**REMARKS**

Claims 1 through 51 are pending; independent claim 25 and its dependent claims 26 and 27 are amended, while independent apparatus claim 51 is newly presented.

# Annotated Sheet Showing Changes

5,828,834

## FIG. 3 (Amended)

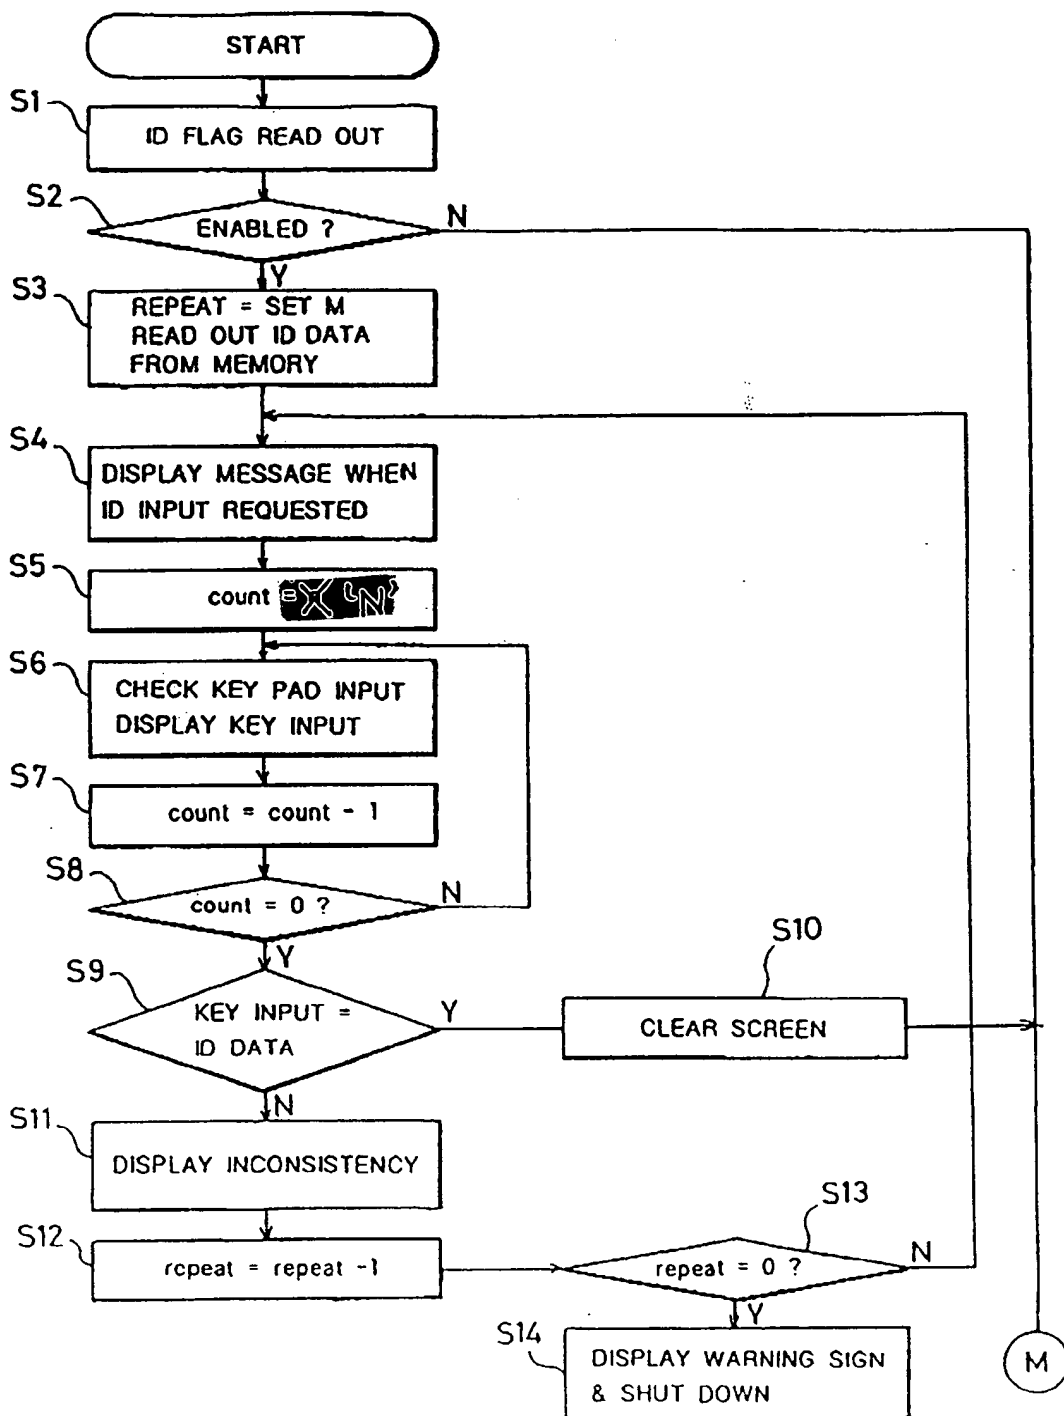
Figures 3, 5(A) and 5(B) are being amended; reference symbol *n* has been amended to '*N*' in block S5 in Figure 3, reference symbol *n* has been amended to '*N*' in block K1, and END has been amended to read "Go To J2" in Figure 5(A), and END has been amended to read "Return to J" in Figure 5(B). Entry of the corrected formal Figures 3, 5(A) and 5(B) is respectfully requested.
